## Solicitation Addendum

Addendum No.: 3  
Solicitation No.: 23-TA004807DJ  
Project No.: 6110580  
Solicitation Title: Force Main 32A Replacement  
Addendum Date: October 12, 2023  
Procurement Contact: Dave Janney, Procurement Agent III

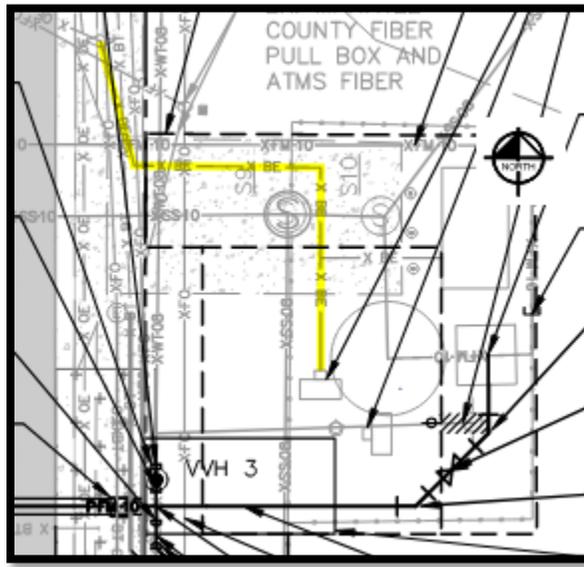
**Q2. Reference plan sheet C-4, the note that reads “EX. BT CABLES (3) TO BE RELOCATED AS NECESSARY TO COMPLETE JACK AND BORE”, relocating buried telephone cable is not something we can do and this work would have to be performed by a telephone contractor and we do not know what the costs for this work will be and or how long it will take, perhaps another Allowance Bid Item should be established for this work.**

**Q3. Reference plan sheets C-3 and C-4, Note numbers 5 – 10, these notes pertain to the existing Advanced Traffic Management System, (ATMS), but the plans do not show installing a new ATMS, how is the Contractor supposed to bid this scope of work?**

R2. Per the note shown on the Sheets C-3 and C-4, it is expected that the contractor will be in conflict with the buried fiber cables through the force main construction (jack and bore box or direct conflict with the jack and bore). The contractor shall include in the cost of the subject force main jack and bore construction, the cost of the fiber conflict resolution (slack the fiber lines or relocate the fiber) necessary to construct the proposed force main. The contractor will be responsible for coordinating with Manatee County ATMS to accomplish this. See Bid Attachment 3 – Plans (Revised), issued with this Addendum 3 and available for download as a separate attachment.

R3. See response to Question #2.

SHEET NO.  
IT-222

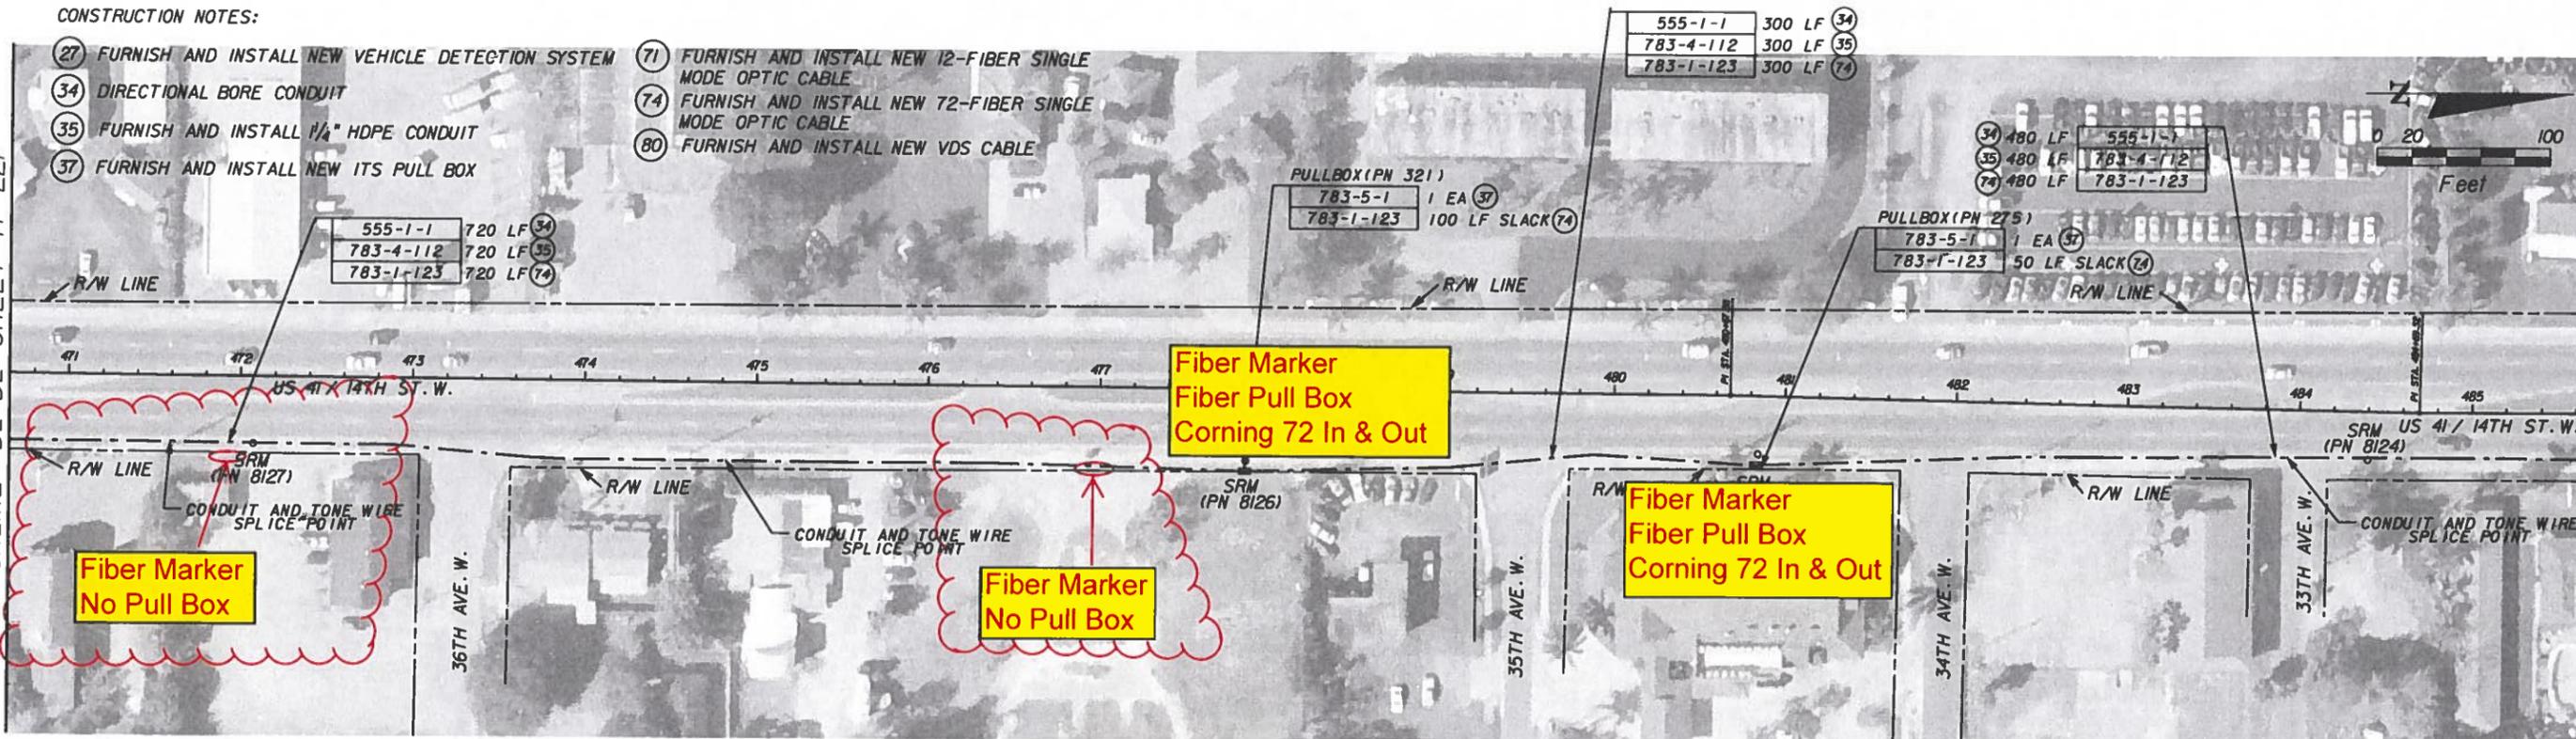
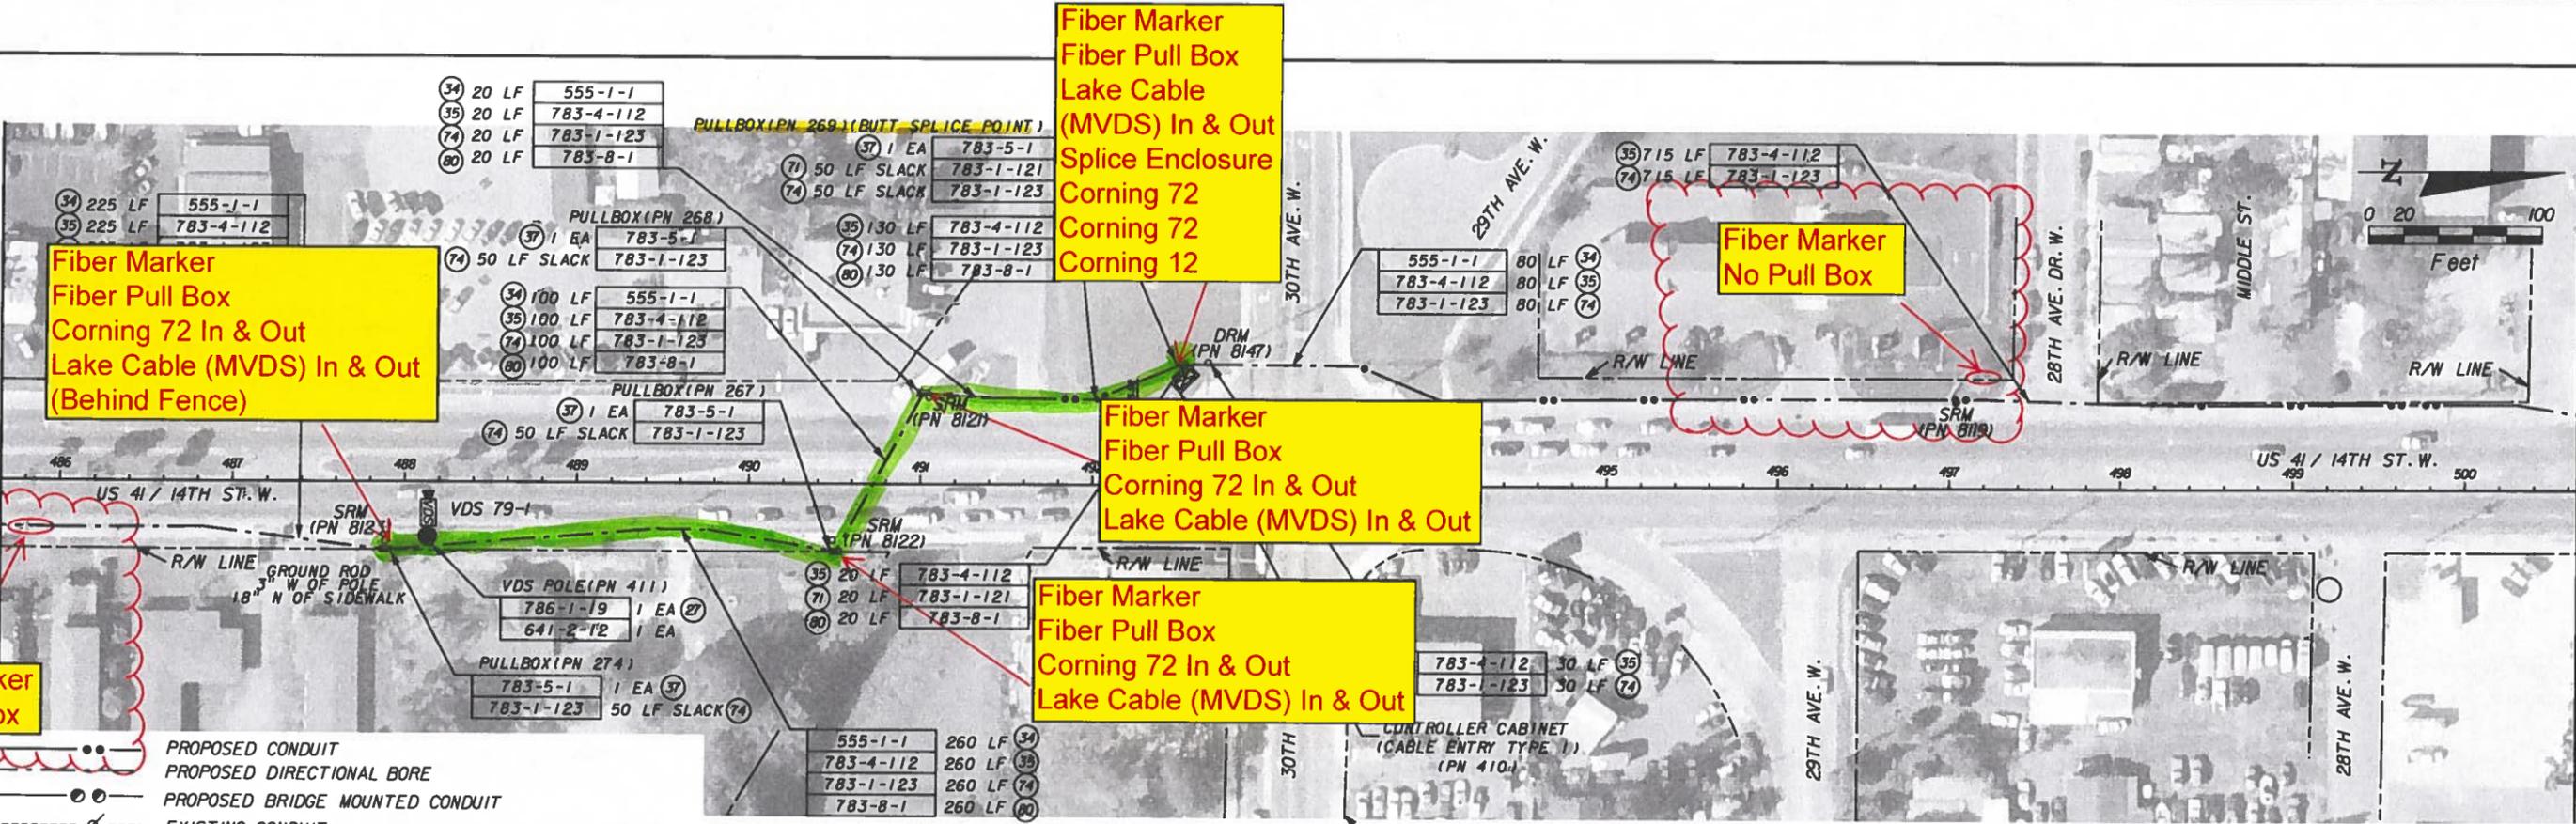
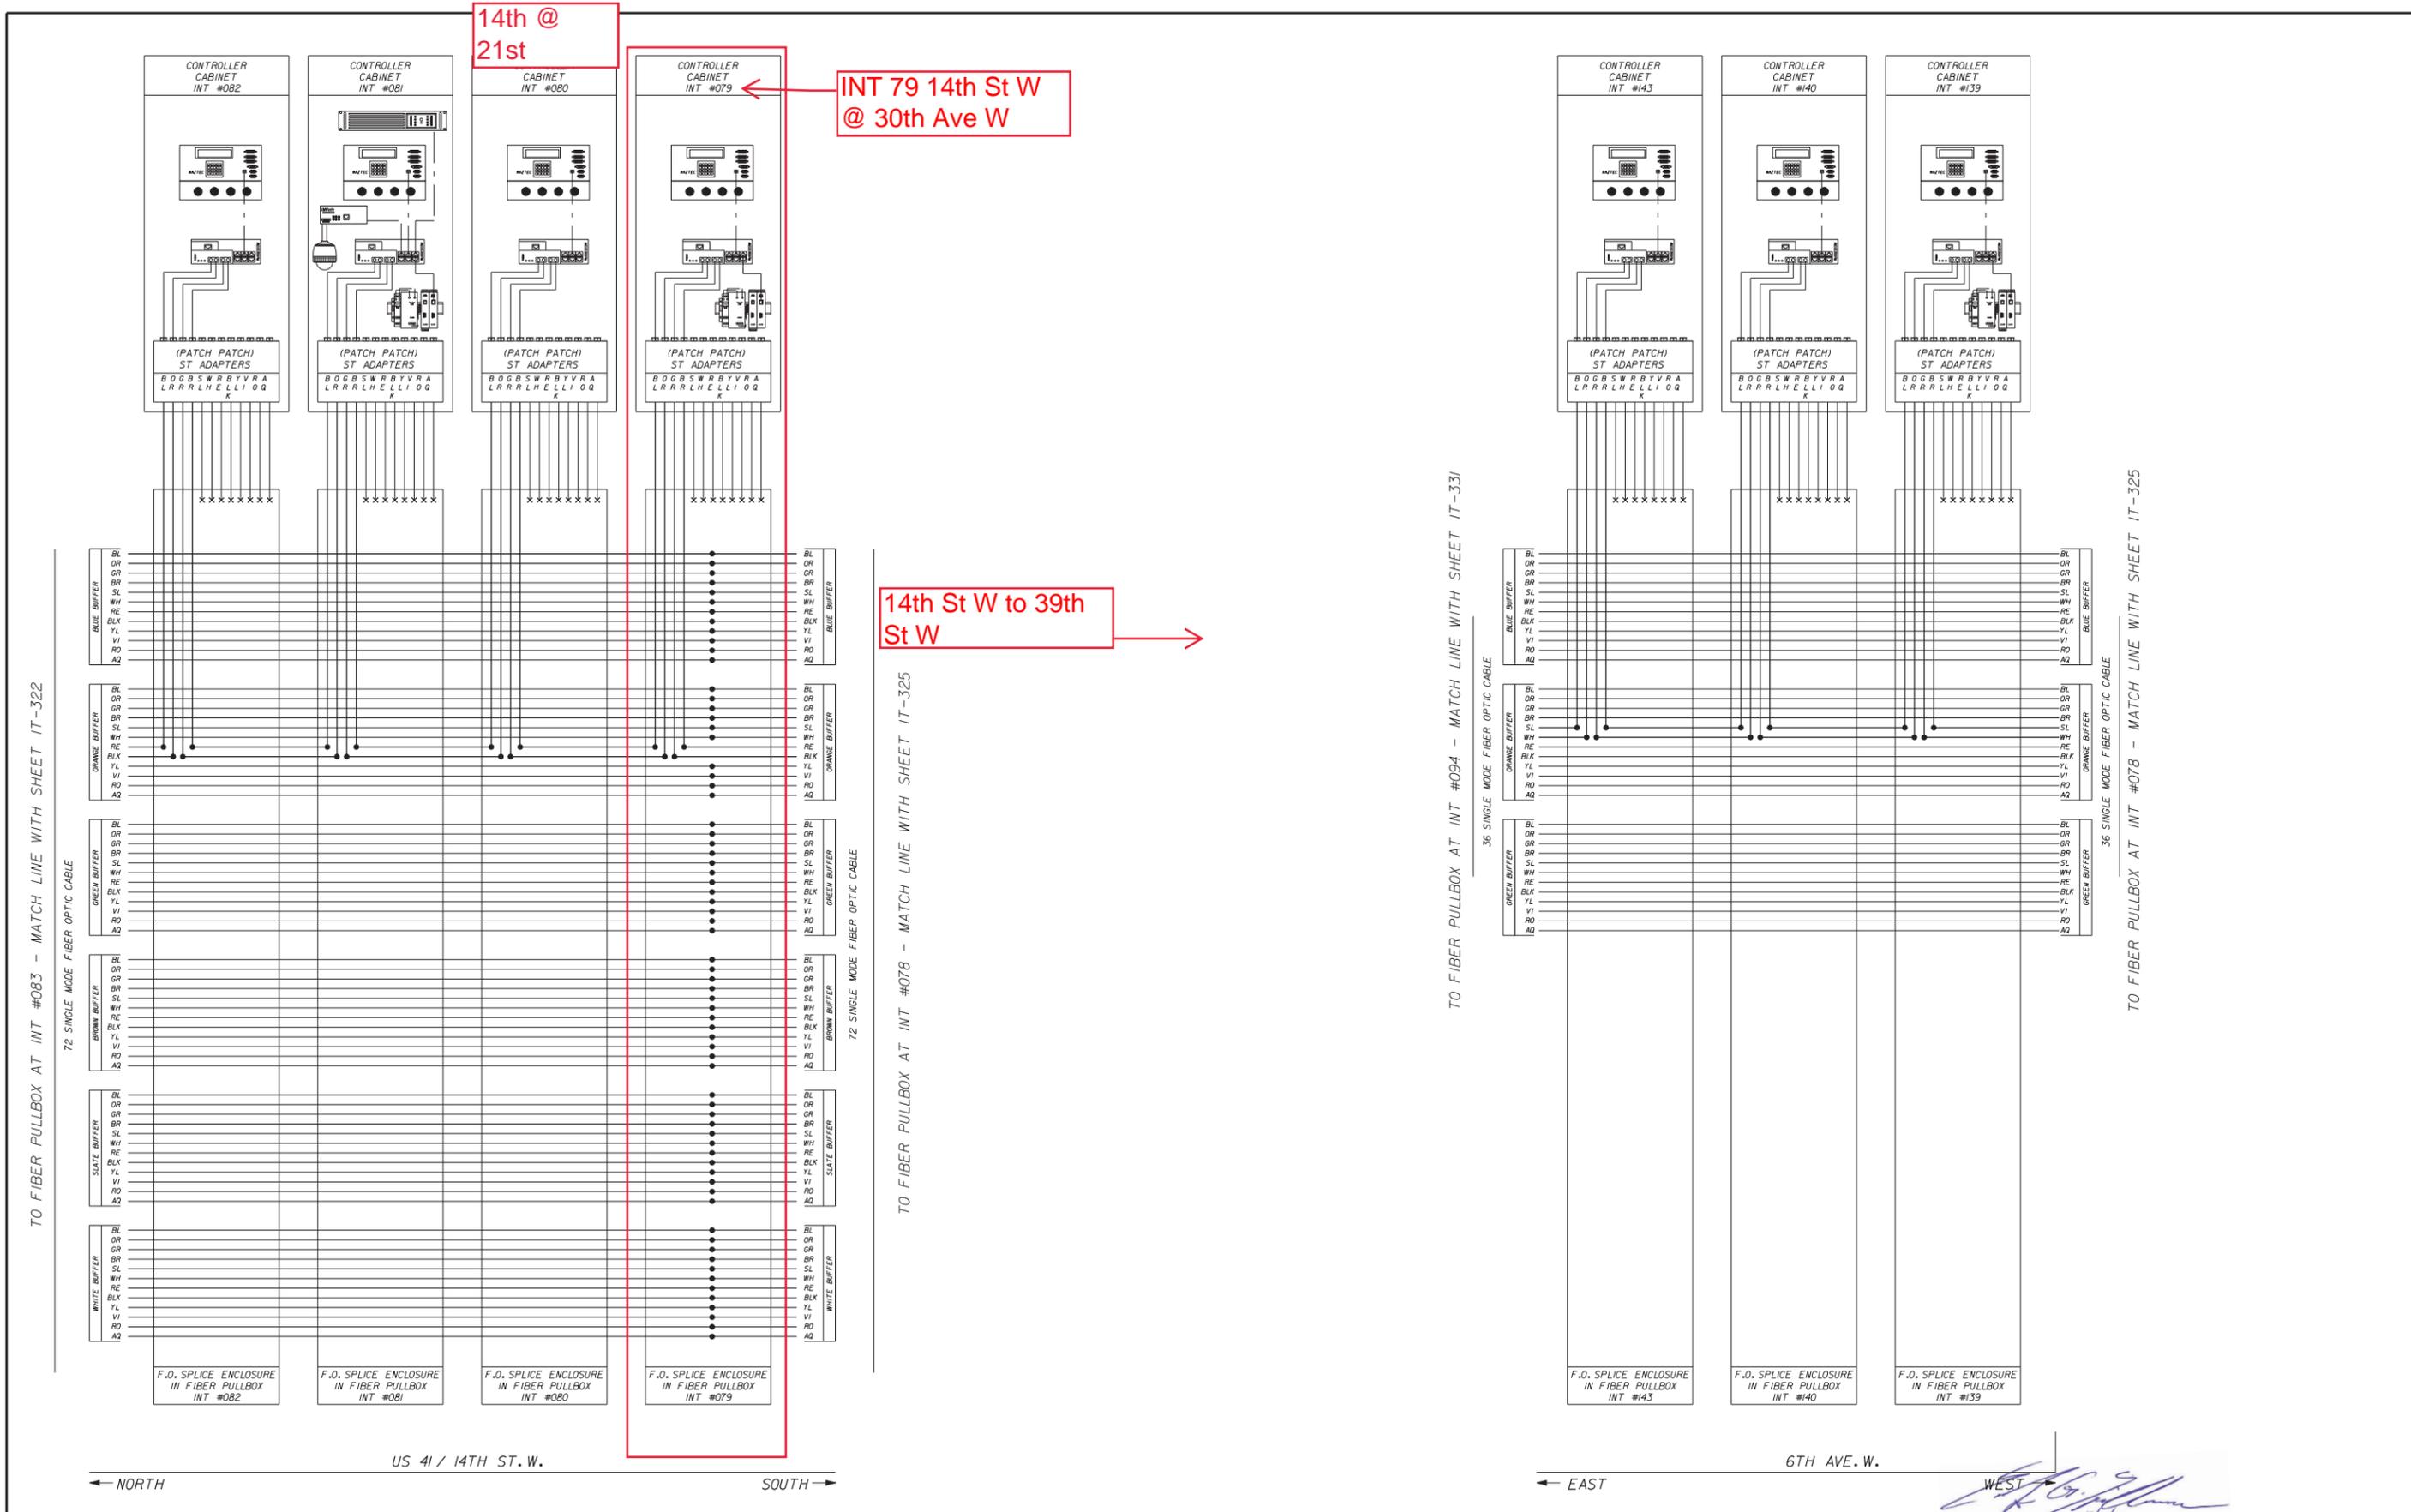
**Q24. With regard to the Automated Traffic Management System, ATMS, the County is requiring the Contractor to provide a splice diagram for any required splicing, does this mean the County will allow a new splice vault to be installed and that new fiber and conduit from the new splice vault to the existing splice vault at 30th Avenue West and 14th Street West is to be installed?**

R24. A short section of the existing ATMS fiber infrastructure appears to be in conflict with the construction based on the record drawings. Please see attached ATMS Fiber Record Drawing with this affected section of fiber marked in green. At a minimum this whole section may need replacement or relocation (includes empty conduit if any). There is a multi-conductor cable running from the Microwave Detection System (VDS 79-1 - See Bid Attachment 3 – Plans (Revised), issued with this Addendum 3 and available for download as a separate attachment.) to the traffic signal cabinet in the SW corner of 14th ST W @ 30th Ave W, in the same conduit as the fiber. This needs to be replaced as well. Also find related splicing diagrams from our as-builts.
